MTU Application Letter
C&I + Agriculture

2018-043 *Friedrichshafen, November 2018*

Notification of Change

Modification Note 2018-E012

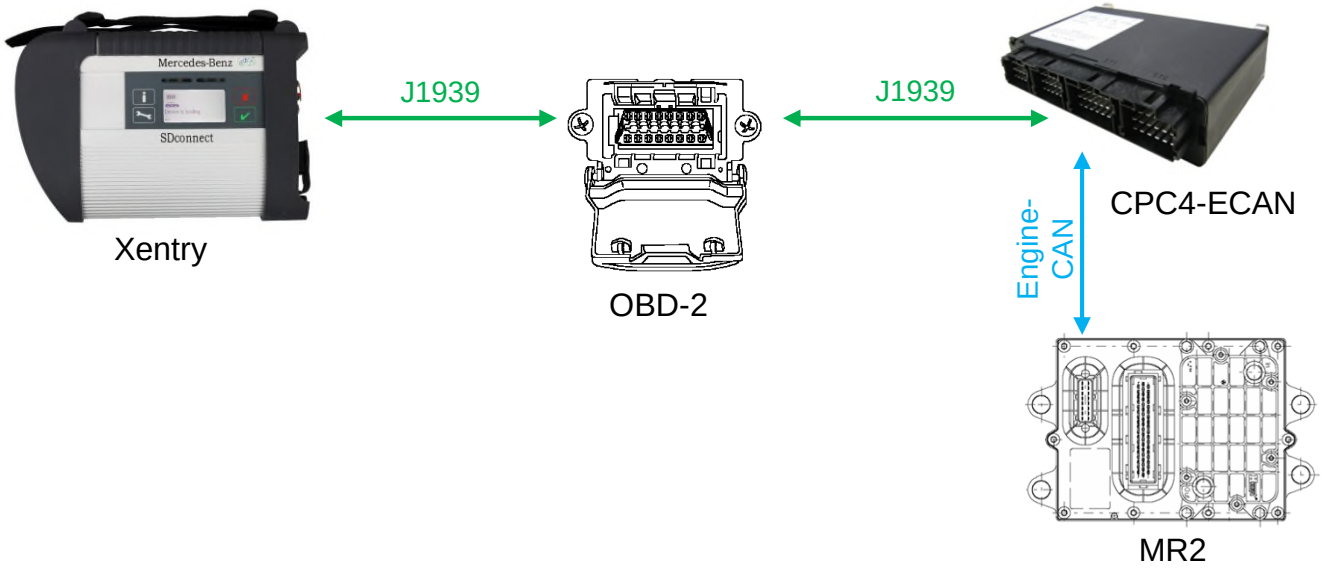
- Diagnosis of the CPC4-ECAN via Xentry-DAS is only supported via CAN-bus (and not via K-Line).
- Diagnosis of the MR2 can also be done via the CAN-bus (the CPC4-ECAN will be used as a ‘gateway’)
- CAN-bus communication / diagnosis with Xentry-DAS via the 14-pin diagnostic connector from the classic engines is not supported.

Pin-assignment
OBD-2 Diagnostic connector (16-pin)

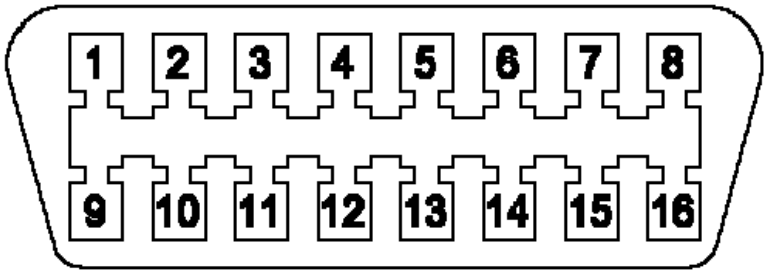
*) For the CAN-connection (to the CPC4-ECAN) only two pin-assignments are needed:

- Pin 6 and Pin 14 (recommended) **or**
- Pin 12 and Pin 13

Note:
Diagnosis with Xentry via pin 6 and pin 14 is not yet available, but the implemention is planned until Q1/2019.
